DOCKETED	
Docket Number:	24-OPT-02
Project Title:	Compass Energy Storage Project
TN #:	257870
Document Title:	Cathleen Pryor Comments - Elevation of hillsides to the immediate west of the facility
Description:	N/A
Filer:	System
Organization:	Cathleen Pryor
Submitter Role:	Public
Submission Date:	7/20/2024 9:16:46 AM
Docketed Date:	7/22/2024

Elevation of hillsides to the immediate west of the facility

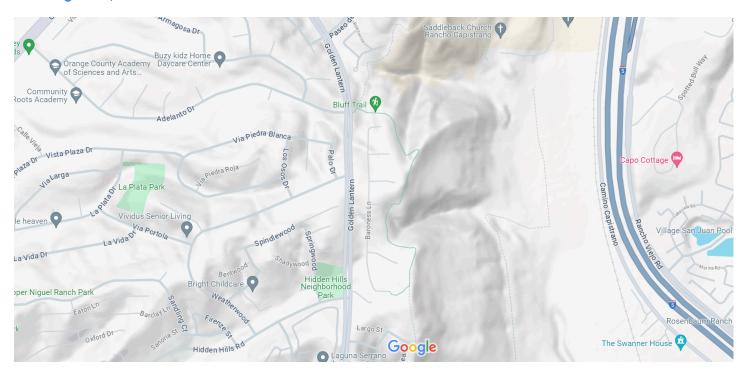
This map illustrates the height of the hillsides of Open Space land next to this facility. If you look closely you can see the area where the facility is would be 200 feet above sea level, this shows the creek is draining to the sea. Then you can see where the 400 feet above sea level line is (half way up the hillside) and the 600 feet about sea level line is. That is not the top of the hillside. The top is higher than 600 feet, these cliffs are steep. All of the vegetation and animal life will create debris that will float down and blanket the containers and infiltrate the a/c units on each container. Once an intake is partially blocked, the a/c is in danger. Once the temperature inside the container rises, the Lithium would heat to unsafe temperatures.

This is not the location for a Lithium Battery Storage facility using containers cooled by small independent a/c units. Please deny this application. There are much better locations for this facility.
